# **METROPOLITAN PROVIDENCE BICYCLE FACILITIES SITE ASSESSMENT PROJECT**

## **SOUTH ELMWOOD BIKE PATH**

**FINAL DESIGN STUDY REPORT**  
April 25, 2005

METROPOLITAN PROVIDENCE  
BICYCLE FACILITIES  
SITE ASSESSMENT PROJECT  
SOUTH ELMWOOD BIKE PATH  
Cranston, Rhode Island  
OVERALL SITE PLAN

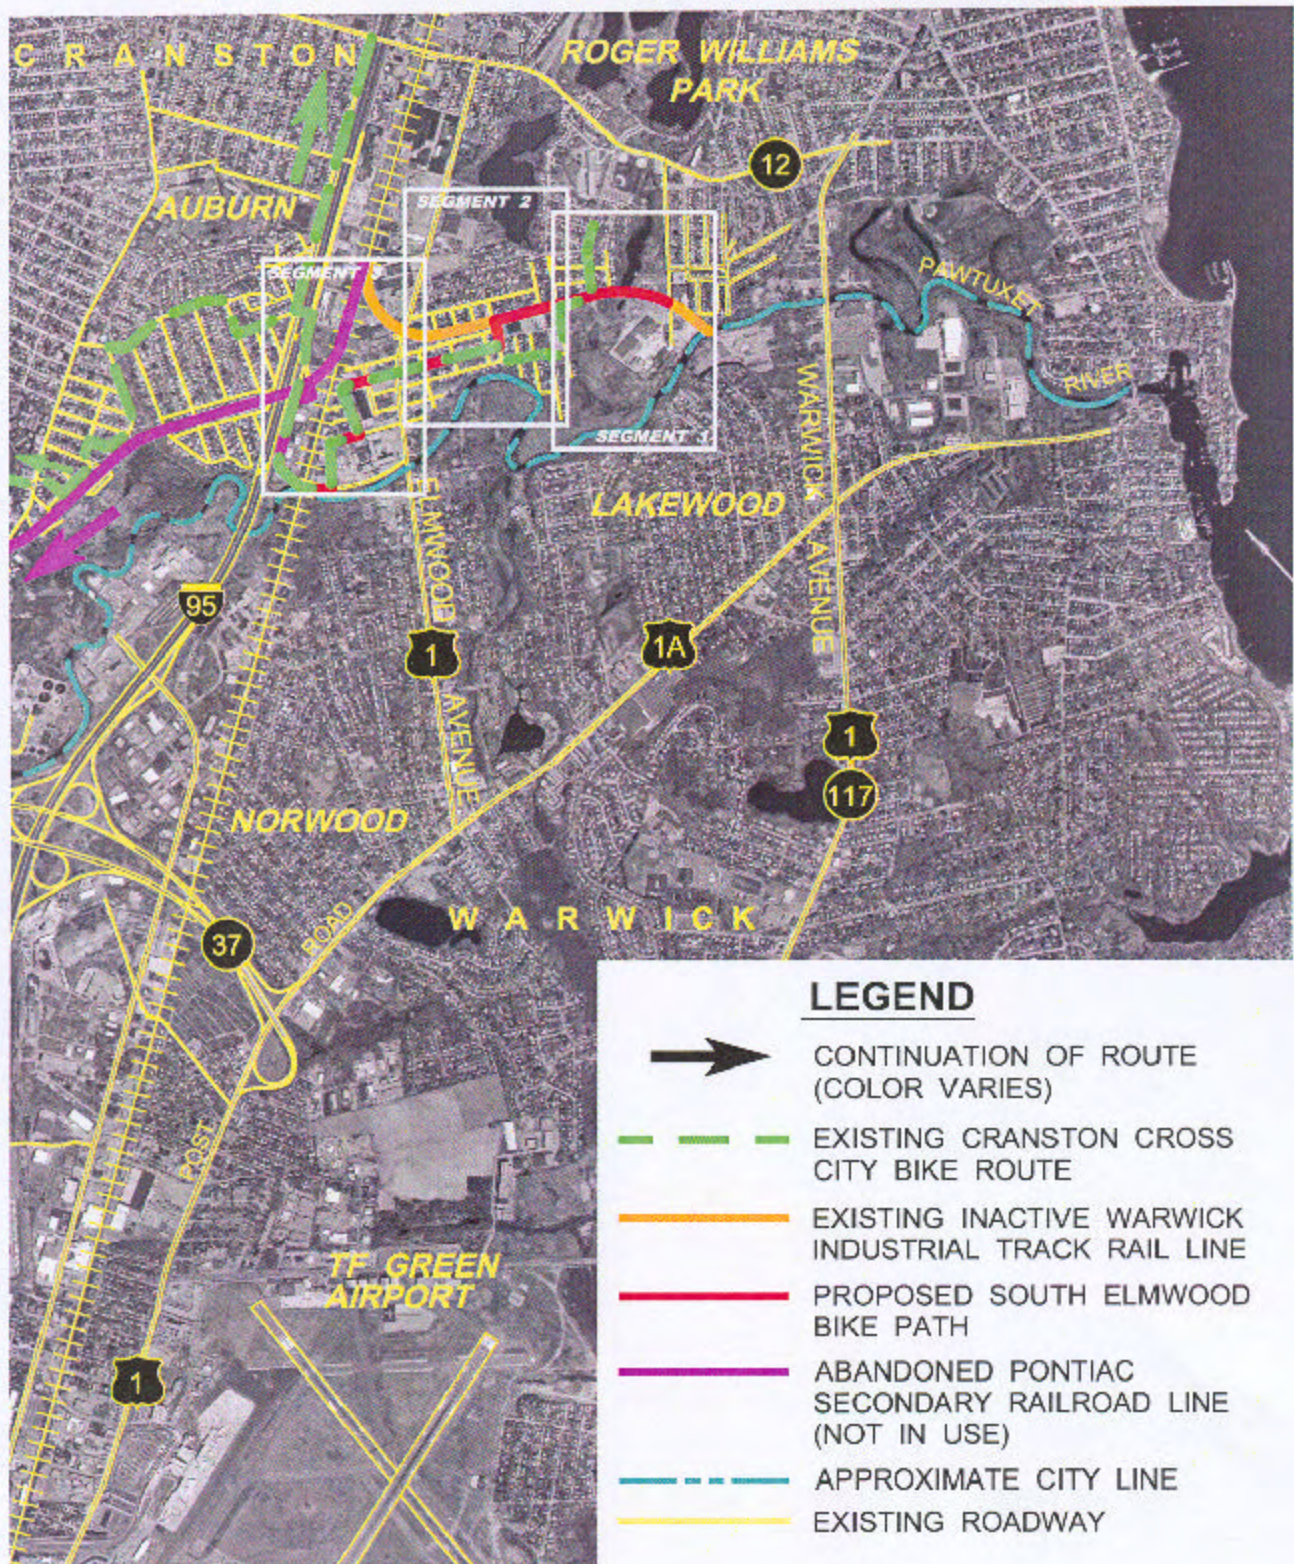
10. **COMMENT:** Pg. 6 Figure 1 – label Pawtuxet River.

11. **COMMENT:** Pg. 6 Figure 1 entitled South Elmwood Spur, shows the Pontiac Secondary also. The figure should show South Elmwood with connection points to the Pontiac.

**RESPONSE:** Pawtuxet River has been labeled.

**RESPONSE:** Figure 1 shows only the South Elmwood Spur information with connection points to the Pontiac Secondary.

METROPOLITAN PROVIDENCE  
BICYCLE FACILITIES  
SITE ASSESSMENT PROJECT  
SOUTH ELMWOOD BIKE PATH  
Cranston, Rhode Island  
BIKE FACILITY CLASS

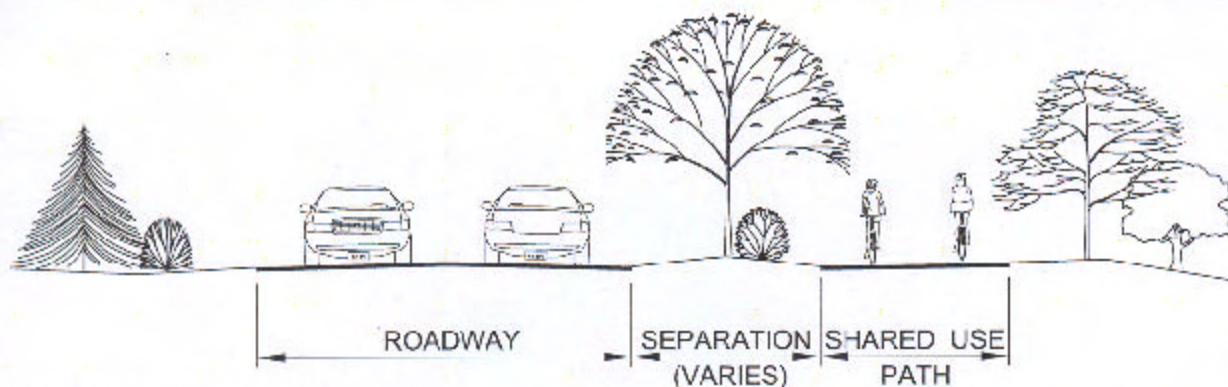
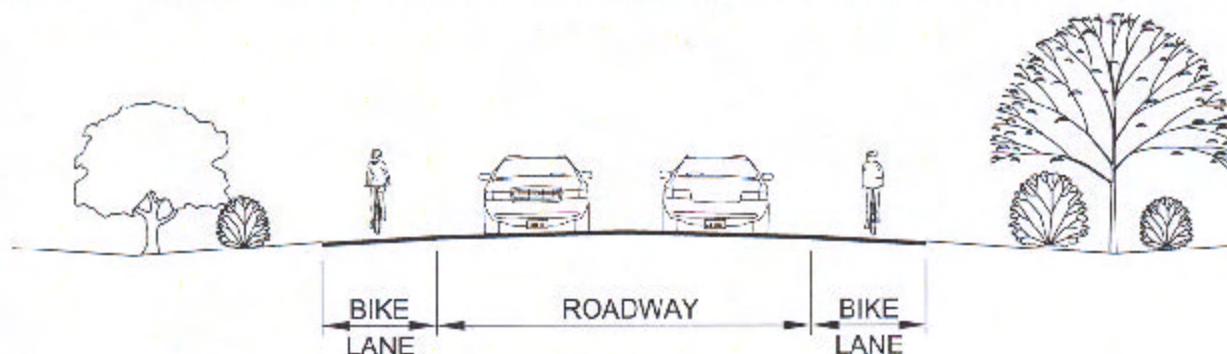
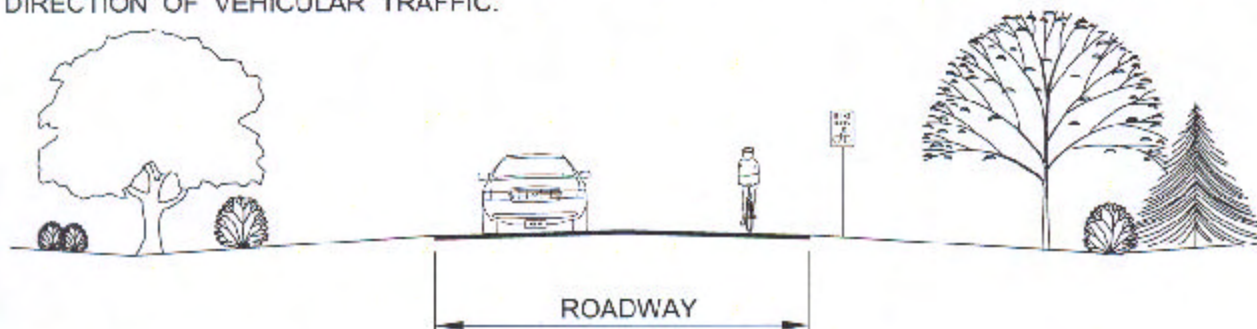
- RESPONSE:** This sentence has been deleted.
15. **COMMENT:** Pg. 11 Figure 4 – Insert graphic with better text quality.
- RESPONSE:** A graphic with better text quality has been included in all five reports.

The described path's proposed signage is to be placed at the approximate locations as indicated on Figure 5, the Segment 1 Plan.

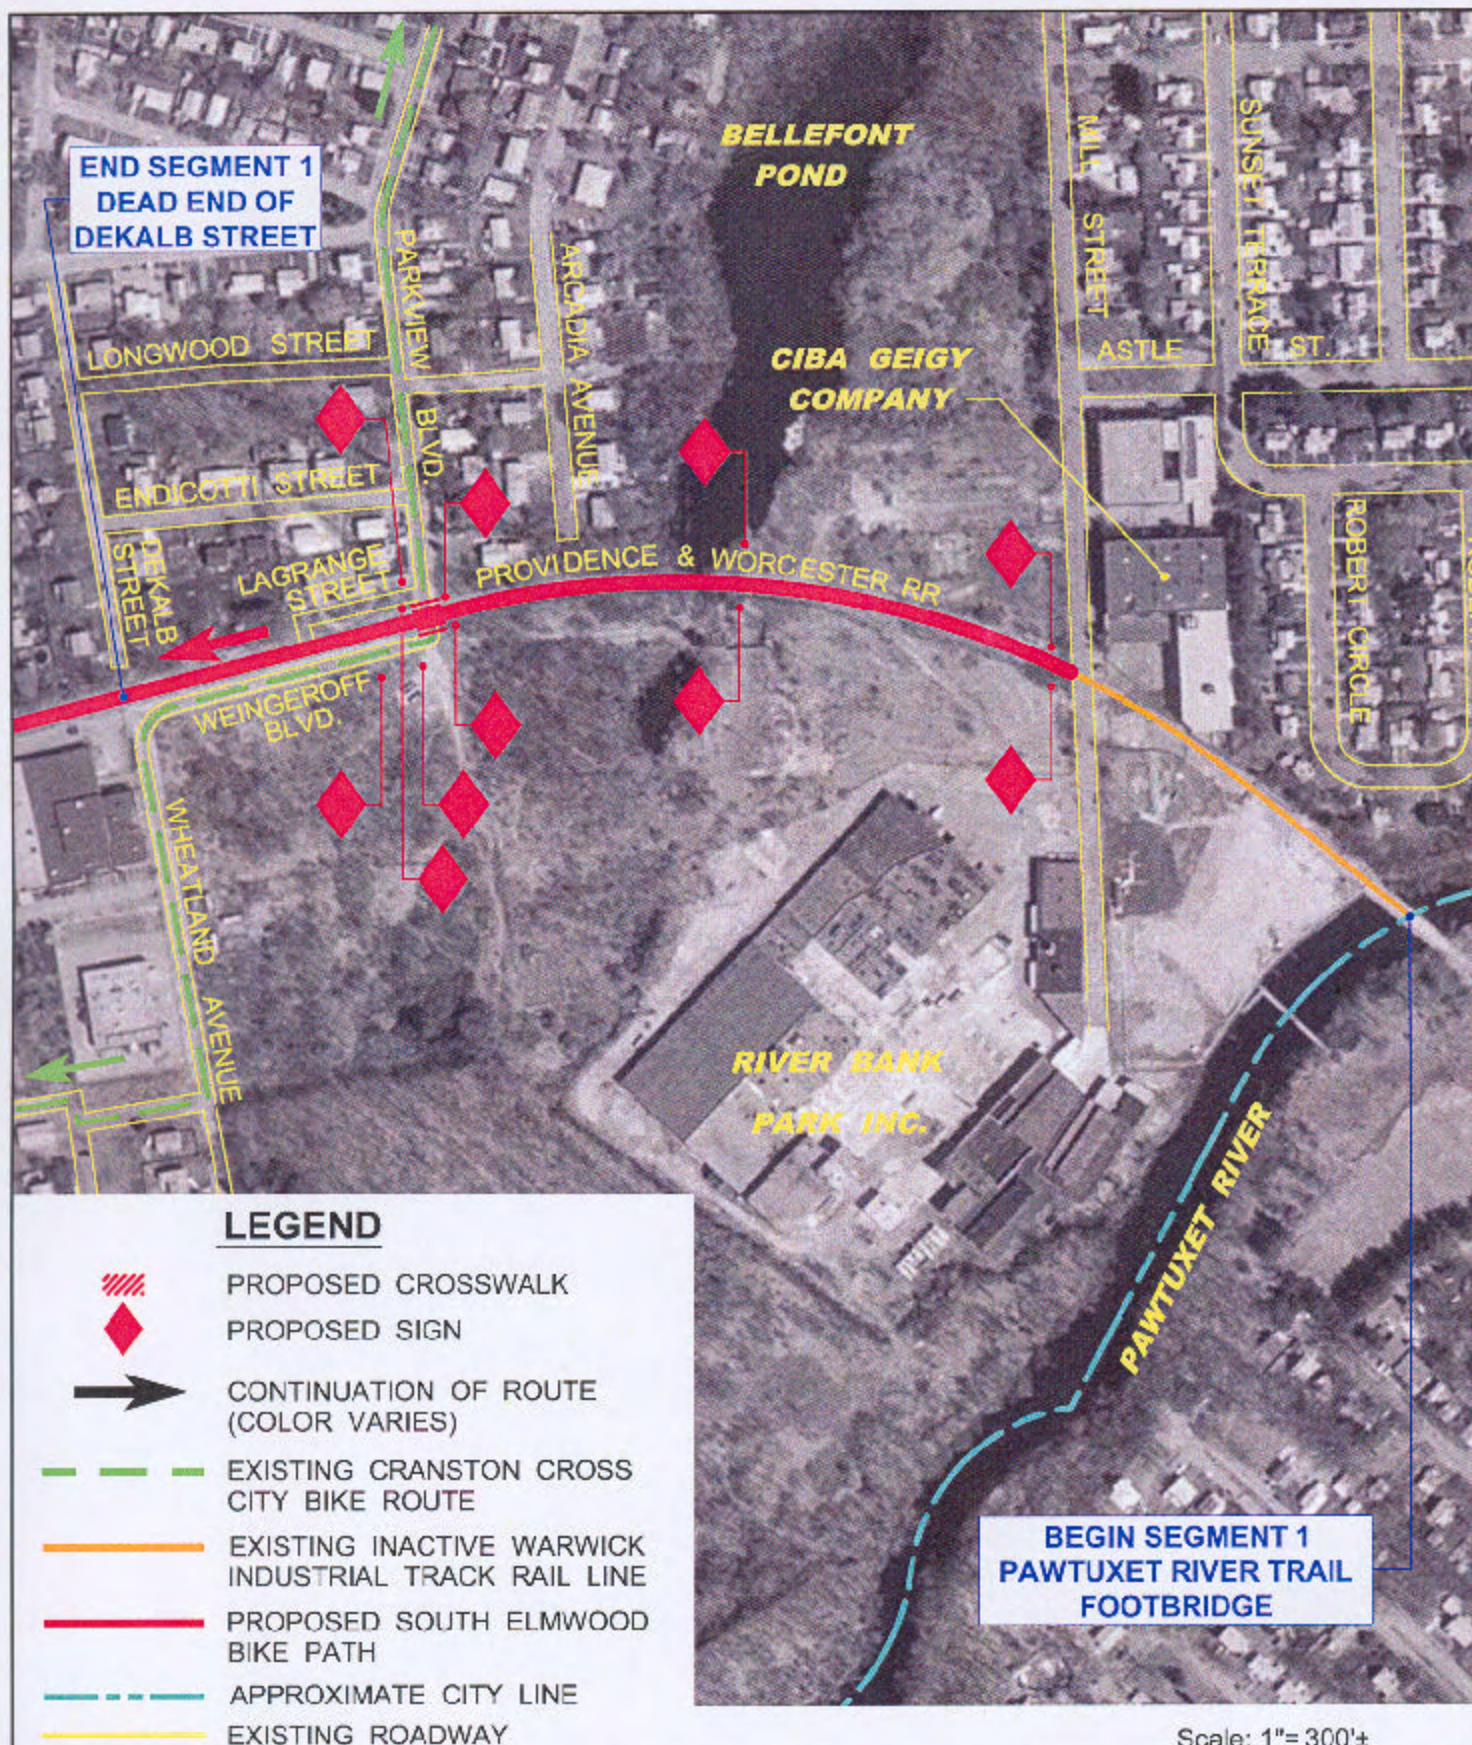
7. Page 15, Segment 1, all figures should indicate the limits clearly. All alternatives should be shown on the figure. (Page 22)
8. Page 22, Elmwood Avenue is mentioned in the discussion on page 15 in reference to the figure on page 22. It is not shown on the figure.

The described bike facility's proposed signage is to be placed at the approximate locations as indicated on Figure 6, the Segment 2 Plan.

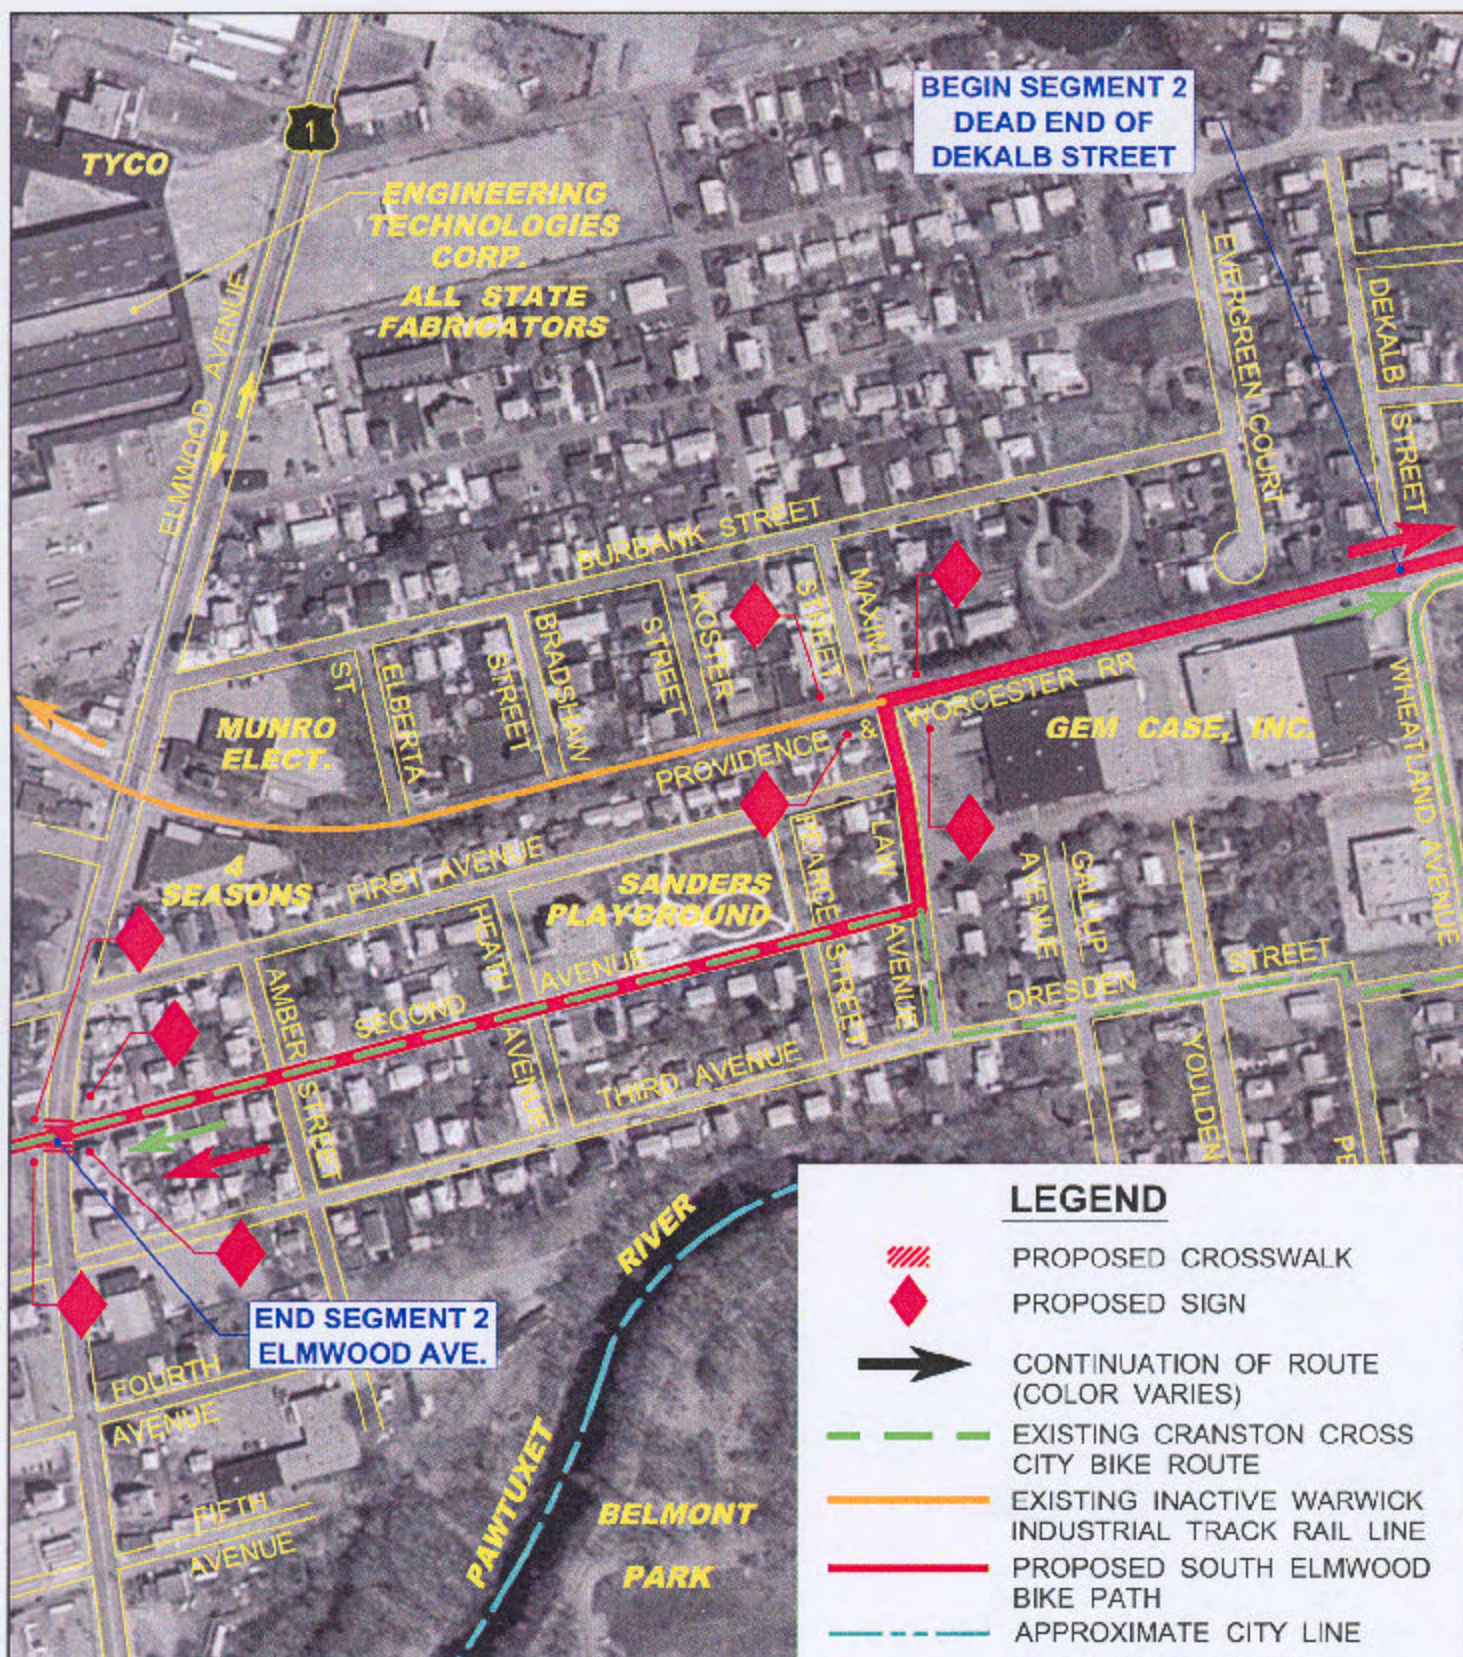
2. **COMMENT:** **Segment 2** – The plan at the intersection of the bike path with Elmwood Avenue calls for bikers to travel south on Elmwood Avenue, in order to connect to the Cranston Cross City Bike Route at Second Avenue. This 500’ stretch would be designated a Signed Shared Roadway. Given, that though not posted, travel speeds of vehicles are often 35-40 m.p.h. along Elmwood Avenue, it may be safer to stripe this section as a bike lane. The neighboring area along the 700-foot portion of the Elmwood Spur easterly of Elmwood Avenue would certainly benefit from the cleanup of debris, tires and discarded appliances along the abandoned rail line. A manually triggered traffic signal should be installed at the Elmwood Avenue crossing for the biker’s safety.

3. **COMMENT:** A suggested alternative to Segment 2, is to follow the bike path from Mill Street to the intersection of Law Avenue, and to proceed in a southerly direction on Law Avenue, to the intersection of Second Avenue, which is part of the signed Cranston Cross-City Bicycle Network. The biker would then follow that route to the Pontiac Secondary Bike Path. This alternative would eliminate the 500-foot section of Shared roadway on Elmwood Avenue, and approximately 1,200 feet of Bike Path construction.

**RESPONSE:** Elmwood Avenue is a two-lane, two-way roadway with approximate 12-foot travel lanes and 0 to 2 feet striped shoulder widths in each direction. According to AASHTO design criteria, to designate a portion of roadway with striping for Bike Lanes, a minimum of 12-foot travel lanes and 4 feet of shoulder are to be provided. Based on these standards, it is not possible for Elmwood Avenue to be striped as a Bike Lane unless the existing lane configurations are refigured to accommodate these requirements. This, combined with concerns about safety, makes the suggested alternative discussed in Comment number 3 more desirable.

**RESPONSE:** This is a viable alternative that would eliminate bicycle traffic on Elmwood Avenue. Elmwood Avenue would still need to be crossed, instead at Second Avenue and a study that involves the investigation of installing a traffic signal would still be warranted.
